SURREBUTTAL TESTIMONY OF STEFFEN MEHL

3. For the surrebuttal phase of Part 1 of the California Water Fix (CWF) hearing, Sacramento County Water Agency asked me to prepare testimony and exhibits responding to the Petitioners' rebuttal testimony of Gwen Buchholz (DWR – 80).
4. In her rebuttal testimony, Ms. Buchholz states:

Figure 1: Water budget errors for each simulated month from the main MODFLOW output file (the listing file) for CVHM-D NAA, CVHM-D Alt 1B, and CVHM NAA.

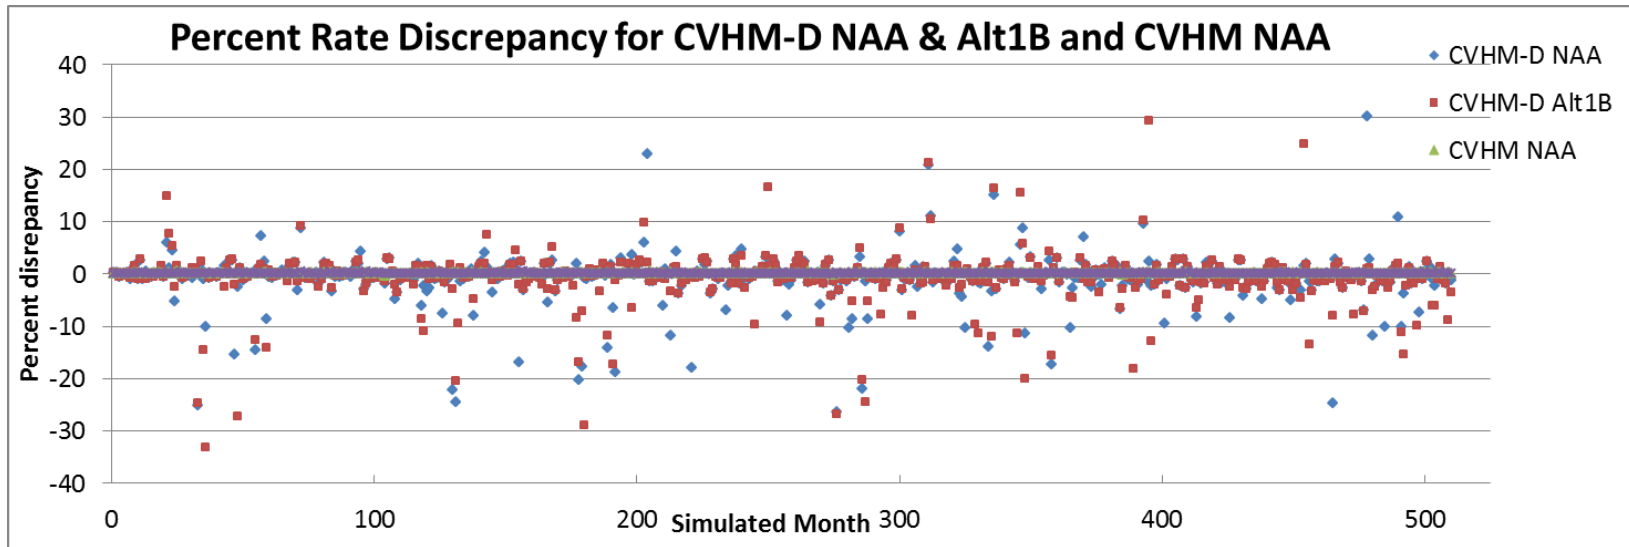
10. Figure 1 shows the percent rate discrepancy in the water budget at each stress period for CVHM-D NAA & Alt1B and CVHM NAA. This discrepancy is an indicator of how precisely the governing mathematical equations in the models were solved. As stated earlier, the water budget is an accounting of the flow of water into and out of the system, which should balance at each simulated time step. Generally, some amount of discrepancy between inflows and outflows occurs due to numerical tolerances and the rule of thumb is that simulations with flow rate discrepancies less than 1% are considered adequate. Simulations with discrepancies between inflows and outflows greater than 1% can indicate that the numerical solution failed to converge with enough precision and/or that other problems exist related to the model conceptualization or design and that the simulated results are not reliable. (Anderson, Woessner, and Hunt, 2015, Applied Groundwater Modeling, pp. 99-100 [Exh. SCWA-201]; Reilly, T.E., Harbaugh, A.W., 2004, Guidelines for evaluating ground-water flow models: U.S. Geological Survey Scientific Investigations Report 2004-5038, pp. 20-21 [Exh. SCWA-202]). As depicted in Figure 1, the CVHM-D NAA & Alt1B scenarios exceed the 1% budget error threshold 57% and 59% of the time, respectively, whereas the CVHM –NAA is always below the 1% threshold. Over half of the simulated results in the CVHM-D NAA & Alt1B models are associated with large budget errors and indicate unacceptably large inaccuracies in the simulated results. These inaccuracies can manifest in numerical anomalies, as described below. Furthermore, there is no guarantee that these numerical inaccuracies occur in a predictable or consistent way between model scenarios which makes comparative analysis between models problematic. Therefore, using the different scenarios only in a comparative way, as stated by Ms. Buchholz on cross examination (April 25, 2017, Vol. 36, 68:13-21), does not guarantee that the comparison provides correct and reliable results.

14. The substantial number of budget errors exceeding the standard threshold of 1% (See Figure 1) and the large head differences in 1969 and 1998 (See Figure 3) indicate numerical instabilities in the model and call into question the reliability of the simulated results. Based on these results and on the budget discrepancies, it is my opinion that some numerical anomalies occur in the model simulation. Therefore, I checked the closure criteria (precision to which the CVHM-D model is simulated) used for heads and river discharge, which can cause the budget convergence issues mentioned above.

Figure 2: Comparison of the water budget components in the No Action Alternative (NAA) and the Alternative 1B scenarios within the South American Subbasin.

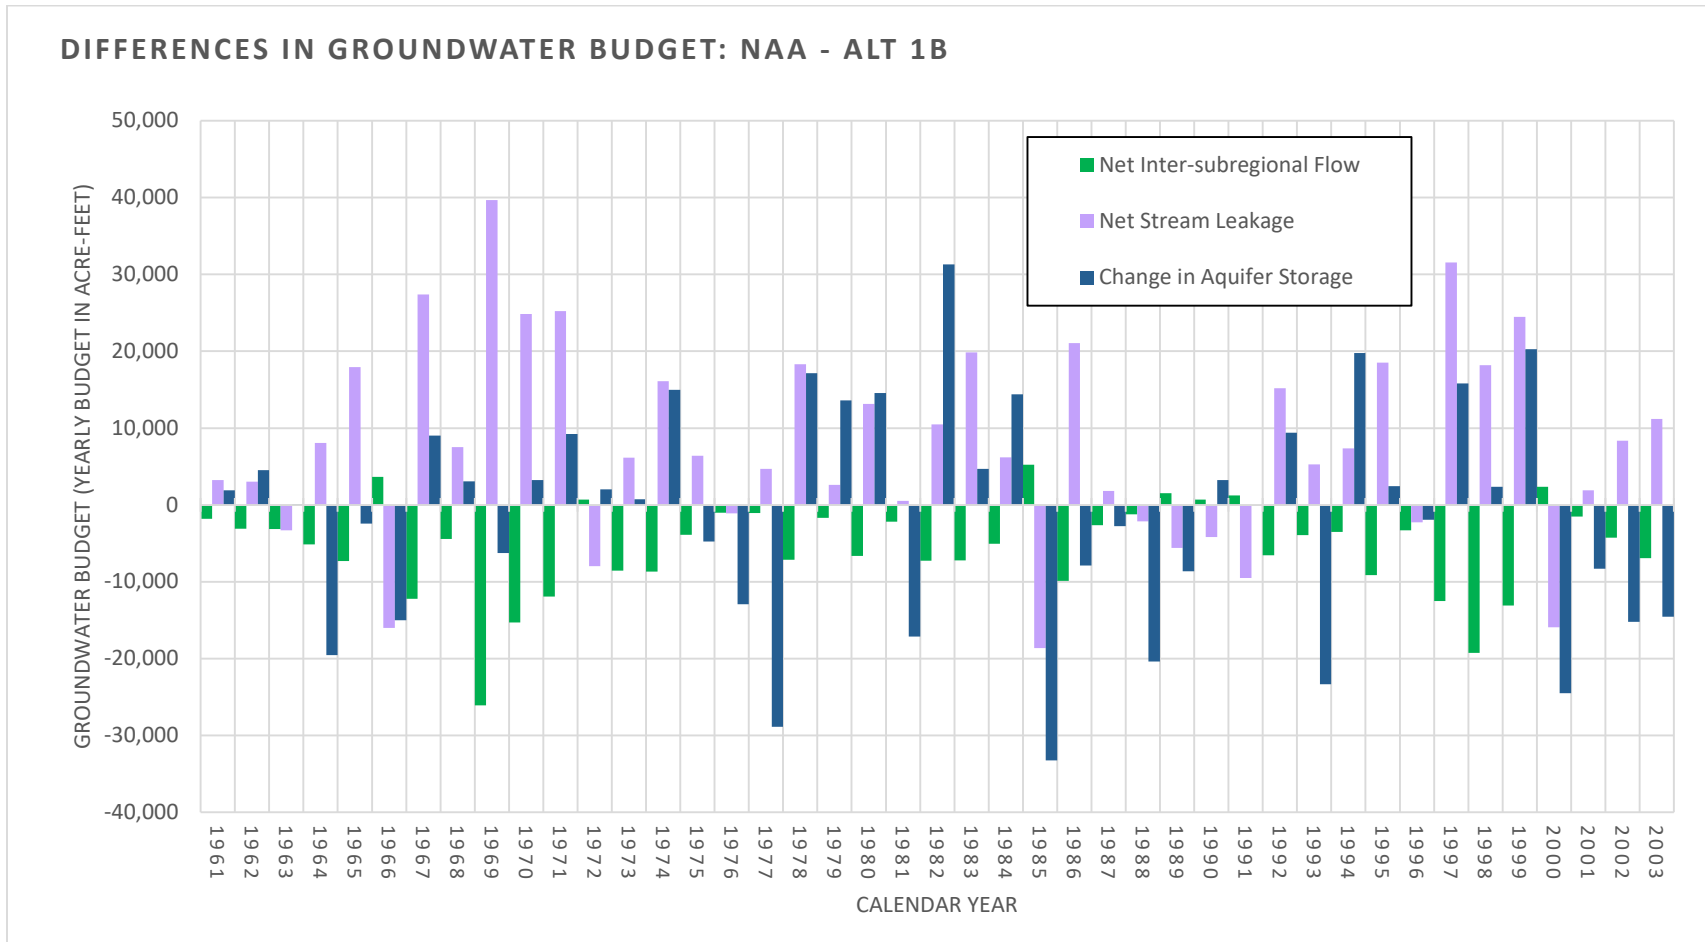
11. Figure 2 shows the differences in the water budget components as calculated by CVHM-D for the South American Subbasin. The net groundwater/surface water exchange seems consistently positive, which would suggest a decrease in stream leakage in the Alternative 1B scenario. Also, the net inter-subregional flow presents significant differences in how water will be exchanged between neighboring subbasins compared to the NAA scenario. More specifically, the South American Subbasin seems to be receiving significantly more water and/or delivering significantly less water from/to the surrounding regions under the Alt1B scenario.

Figure 3: Using the CVHM-D model: max difference in hydraulic head between the No Action Alternative (NAA) and the Alternative 1B scenarios in the South American Subbasin

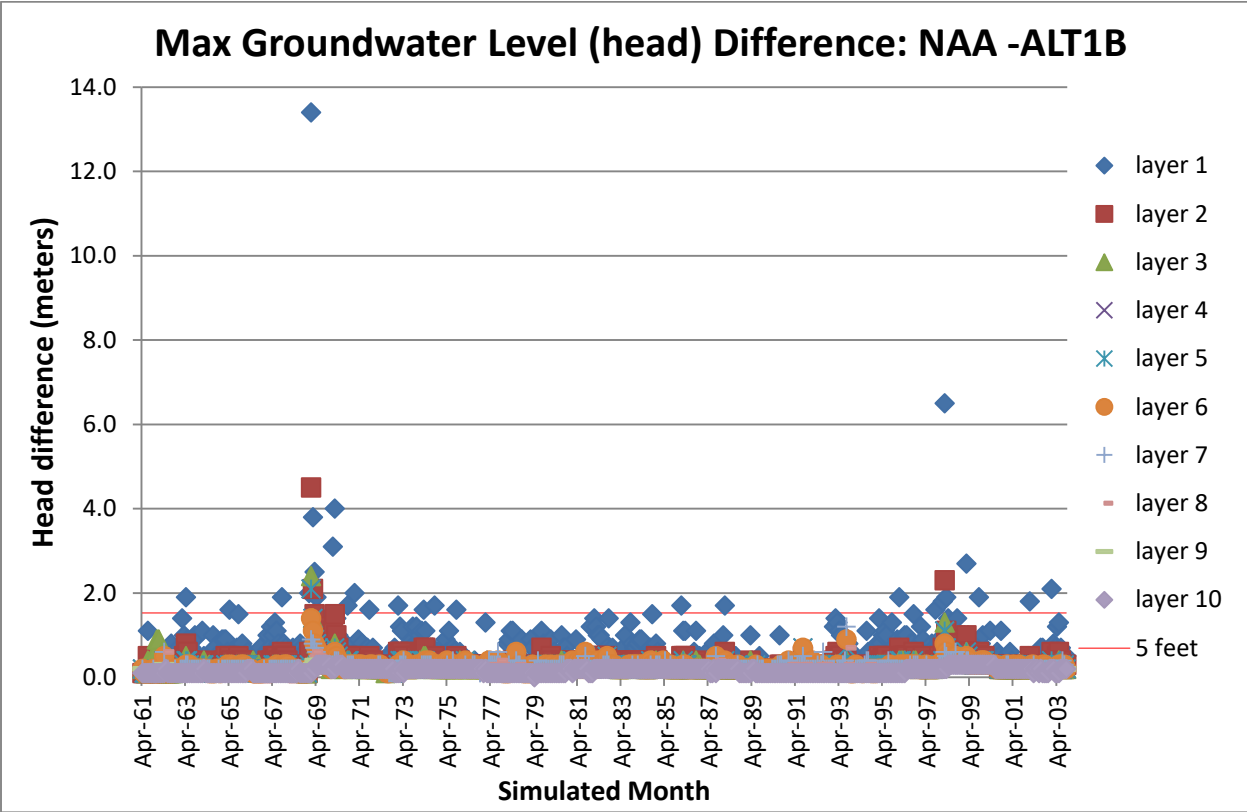
12. Ms. Buchholz states that “groundwater adjacent to the Sacramento River between Intake 1 and Rio Vista would decline up to 5 feet.” (DWR-80, 20:15-16.) During cross examination, Ms. Buchholz emphasized that the model revealed changes from zero to five feet. (April 25, 2017, Vol. 36, 60:12-14, 63:9). Based on the results shown in Figures 1 and 2, we analyzed the changes in South American Subbasin groundwater elevations in the two scenarios. Figure 3 graphically represents the maximum groundwater head (level) differences in all 10 CVHM-D model layers. The maximum head difference between the NAA and Alternative 1B is 13.4 m in January of 1969 (approx. 44 ft), which is much larger than the 5 foot maximum (approx. 1.5 m) stated in Ms. Buchholz’s testimony. As shown in Figure 3, maximum head differences larger than 5ft occur 34 times throughout the simulation period. During cross-examination, Ms. Buchholz stated that the maximum head difference of up to 5 feet mentioned above was verified by checking the output files. (April 25, 2017, Vol. 36, 60:14-17].) Figure 4 presents a screenshot of the output files (obtained from the original CVHM-D files provided by the Petitioners) for the simulated heads for NAA and Alt1B and the location that corresponds to the maximum difference has been highlighted. Figure 5 shows where the maximum head difference is happening along the Sacramento River, downstream of the NDD.

Figure 6 a: Using the CVHM-D model: comparison in water use components obtained with the CVHM-D model with DLEAK = 100 and DLEAK = 25 for the NAA. The budget components are calculated for the South American Subbasin.

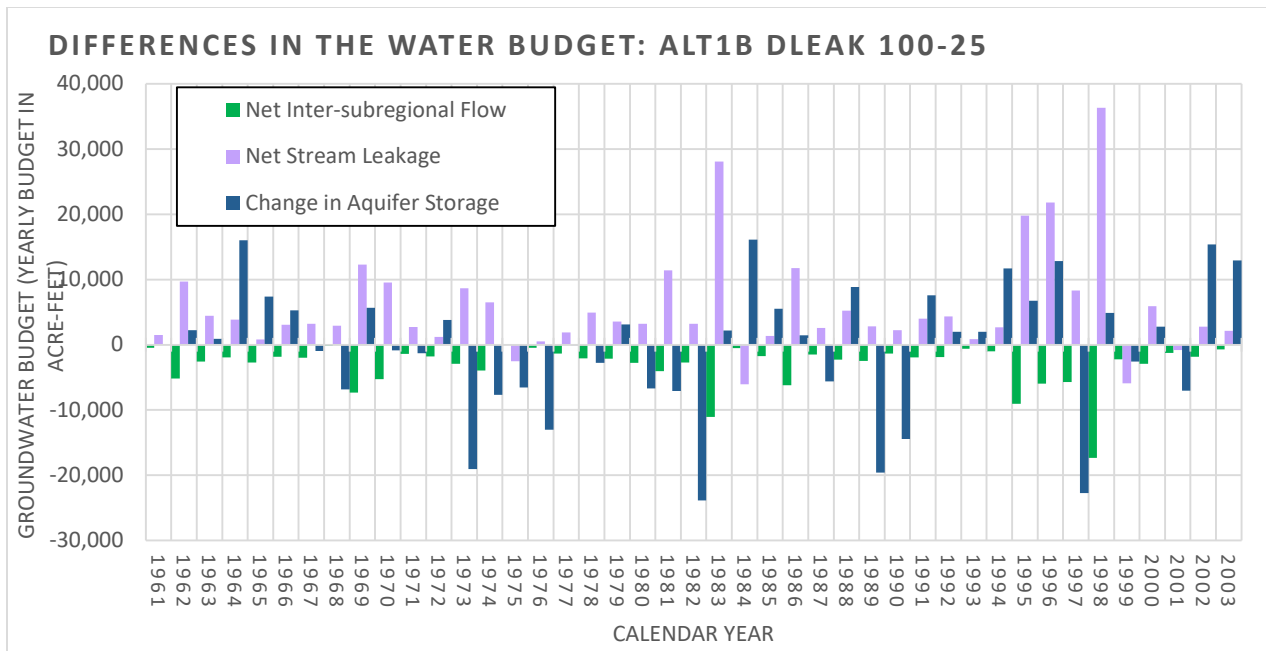
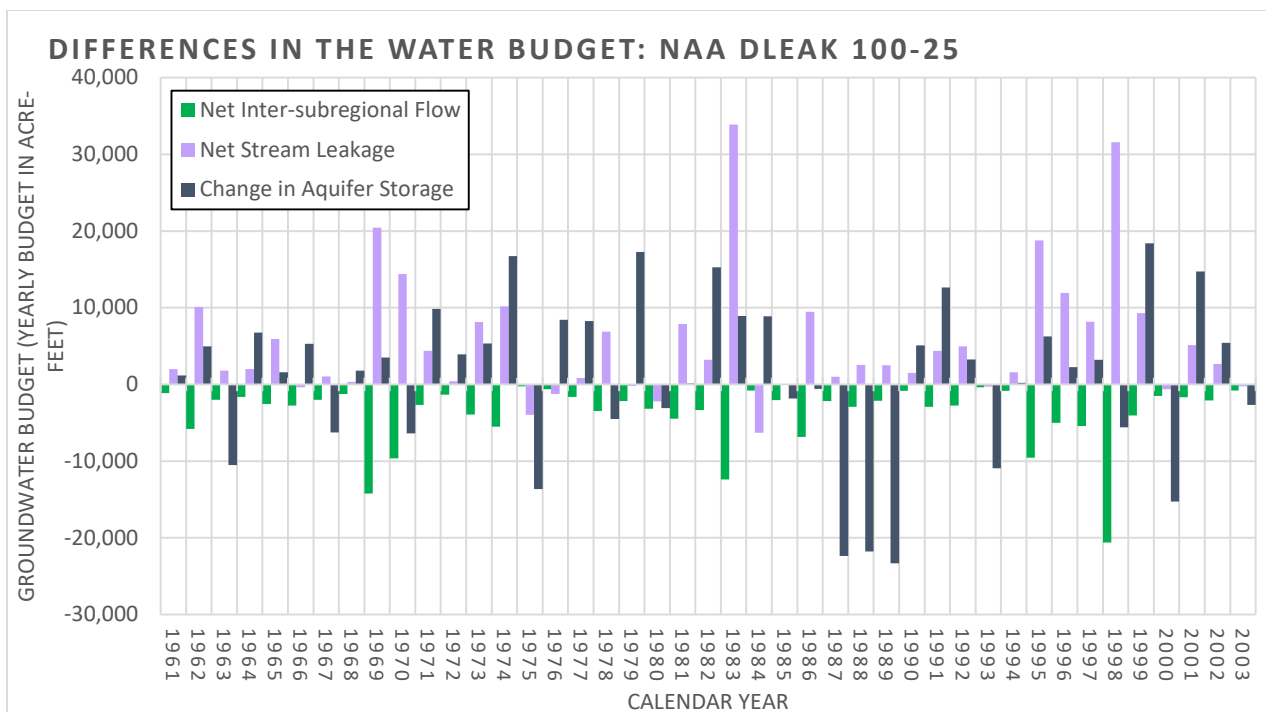
17. Figure 6 a and b show the difference in the water budget in the South American Subbasin between CVHM-D Alt 1B with DLEAK=100 and CVHM-D Alt 1B with DLEAK=25 and between CVHM-D NAA with DLEAK=100 and CVHM-D NAA with DLEAK=25. If the value of DLEAK of 100 were sufficiently small to lead to a numerically precise solution, then decreasing DLEAK to 25 would produce only minor changes in the simulated results. Instead, Figure 6 a and b show that the volume of water exchanged between groundwater and surface water is significantly affected by changing the DLEAK coefficient. For example, the difference in stream/aquifer interaction is over 30,000 acre-ft in 1998 just by changing the precision of the model for representing streamflows. This indicates that the simulated results have a large amount of noise and even their use in a comparative analysis is questionable.

Figure 7: Comparison in the estimated agricultural pumping using Alternative 1C and Alternative 1B for the South American Subbasin.

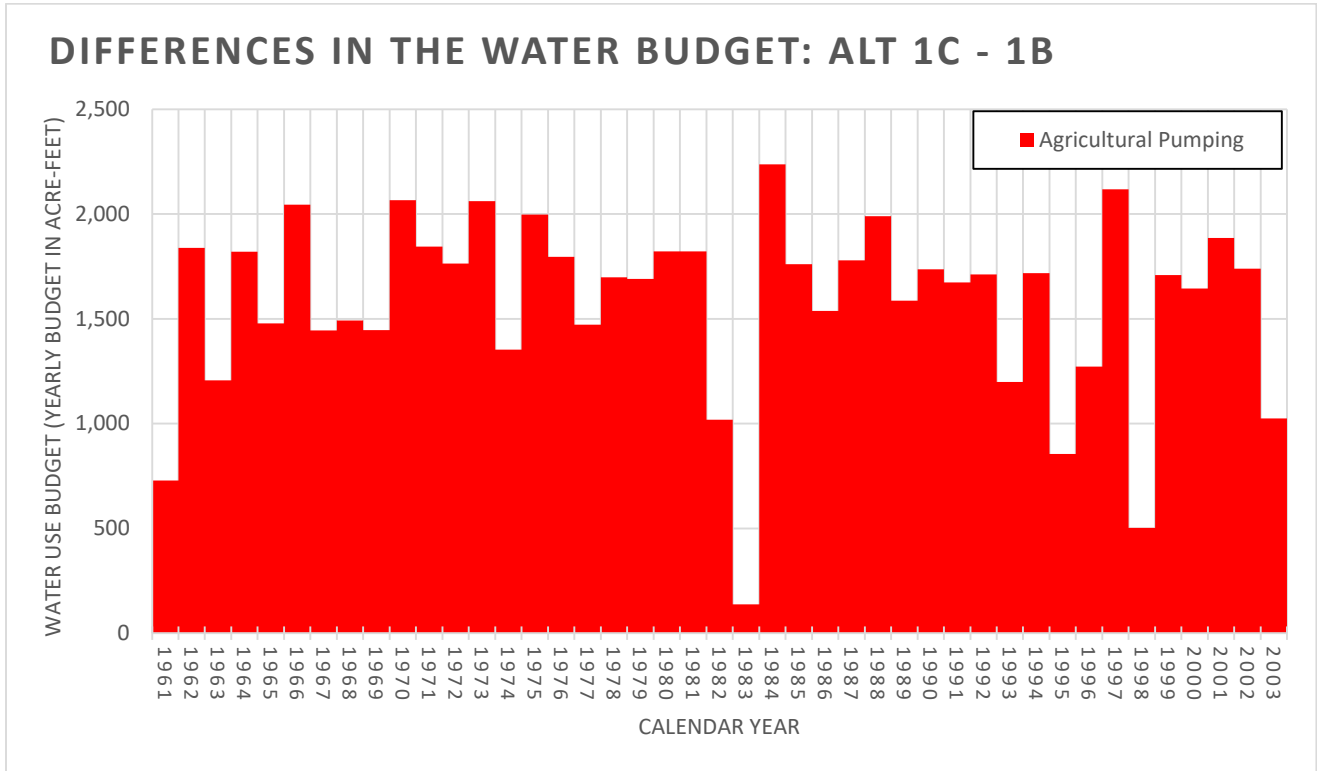
20. In response, I evaluated Alternative 1C and Alternative 1B, and noted differences in agricultural groundwater pumping. (I used Alternative 1C to demonstrate the differences between models because it is my understanding that Petitioners have not modeled potential groundwater impacts associated with Alternative 4A operations. [April 25, 2017, Vol. 36, 74:14-25—75:1-8].) I agree that the municipal pumping does not change in the different CWF alternatives, but the agricultural pumping is internally calculated by the model and it depends on the flow in the entire system. Figure 7 shows the comparison between the agricultural pumping estimated by Alternative 1C and Alternative 1B for the agricultural pumping estimated by the two alternatives for the South American Subbasin. The model calculates the agricultural pumping as a function of landuse, availability of surface water, soil moisture and other factors, and therefore the estimated pumping can be different for each scenario and strongly connected to the other terms of the water budget, such as stream leakage and interbasin flow.

Figure 8 a) Cumulative difference in the volume of the Sacramento River leakage between CVHM-D NAA and CVHM-D Alt1B.

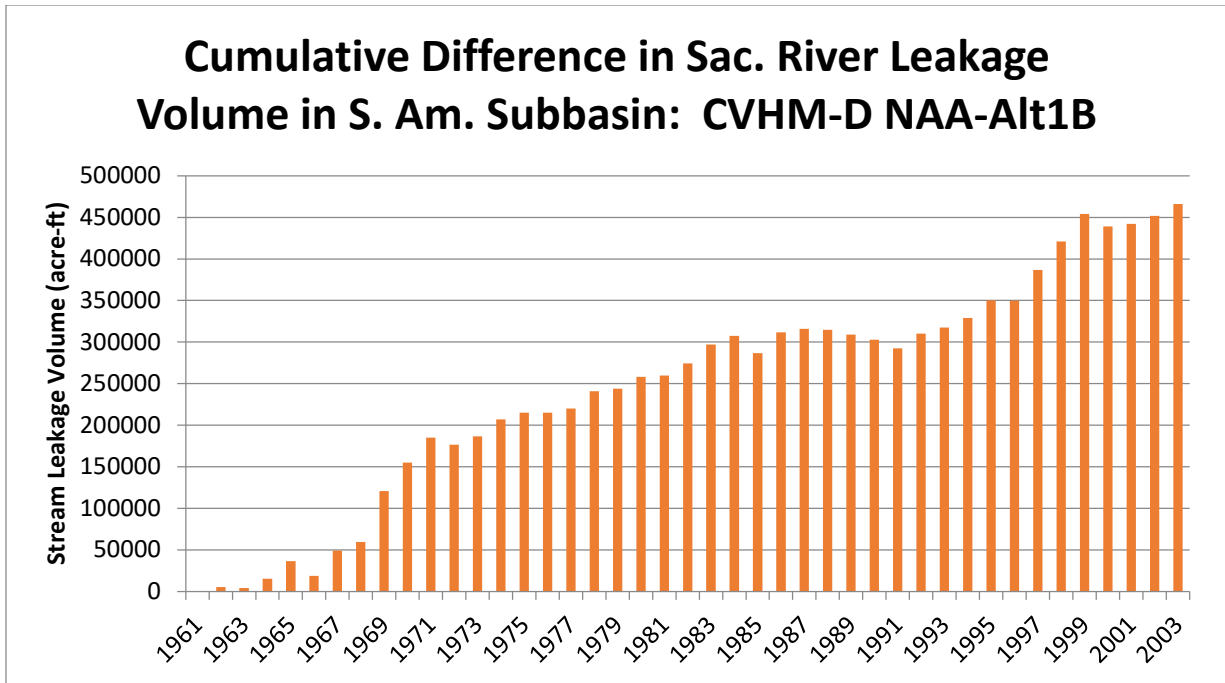
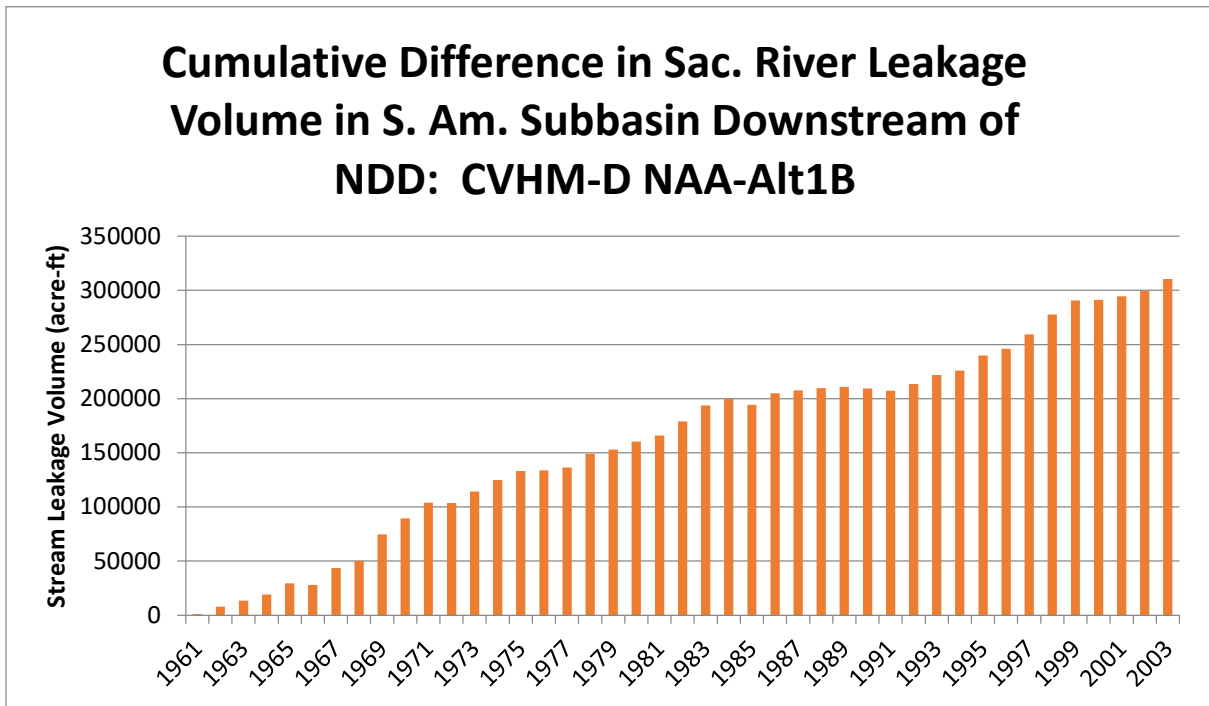
22. I extracted stream leakages from the CVHM-D NAA and Alternative 1B budgets and compared the two to understand the impact of the CWF on stream leakage in the Sacramento River. Given the modeling inaccuracies cited previously, I consider this a qualitative assessment. As shown in Figure 2, the water exchanged with the neighboring basins is affected by the different scenarios. Figure 8a represents the cumulative difference in stream leakage from the Sacramento River along the entire length adjacent to the South American Subbasin, and Figure 8b just the length downstream of the last intake of the North Delta Diversion. Of note are the large

cumulative differences, with most of this occurring downstream of the North Delta Diversion. The positive cumulative difference combined with mostly negative leakage (gaining stream) along this portion of the Sacramento River indicates the Alt1B scenario has more water draining from the aquifer into the Sacramento River than the NAA. Again, this should only be considered a qualitative analysis. To draw more quantitative conclusions on the impact, it is necessary to refine the model such that numerical anomalies in the model that I demonstrated above are mitigated.
